Job 23-7720-R01	Truss R02RP1	Truss Type Piggyback Base	Qty 8	Ply 1	LOT 29 PROVIDENCE CREEK 45 COTTONSEED LANE FUQUAY-VARINA, Job Reference (optional)
--------------------	-----------------	------------------------------	----------	----------	---

REPAIR(S) REQUIRED

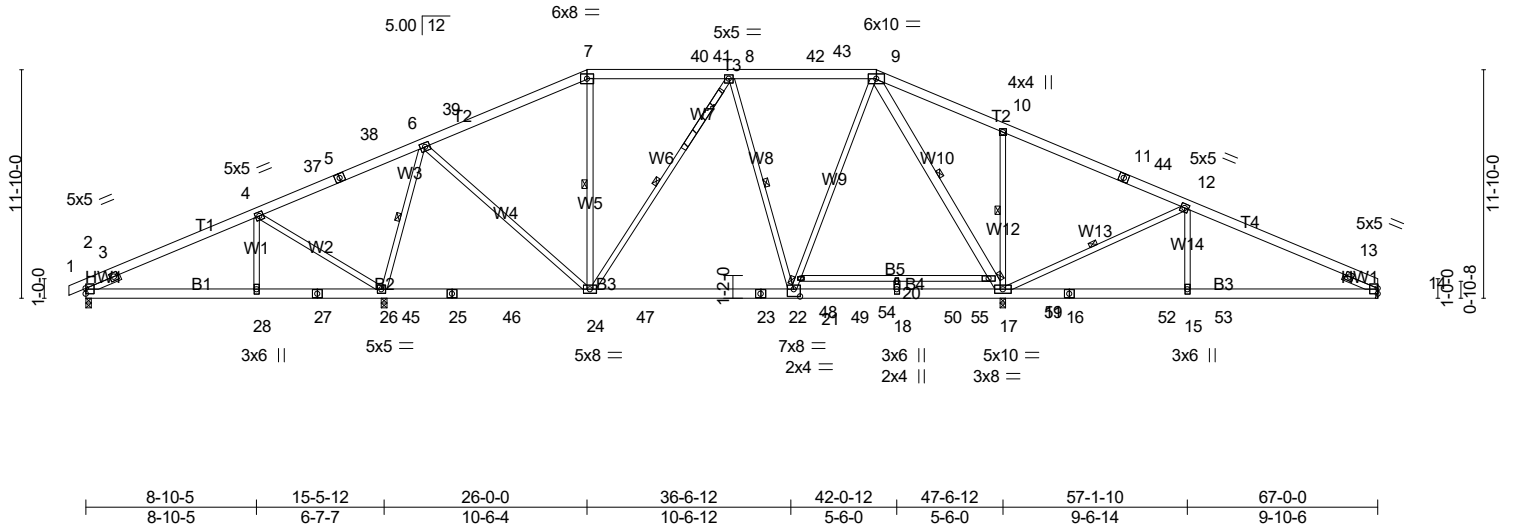
NOTES- (16-19)
 1) Repair Condition: web has 0-8-0 long break centered at 2-6-0 below joint 8.
 2) Apply 49" long 2x4 SP No.2 scab to front side(s) of truss centered on damage located 2-6-0 below joint 8 with 2 row(s) of 10d (0.131"x3") nails spaced 2" o.c. from front face. Minimum 0-3-0 end distance.
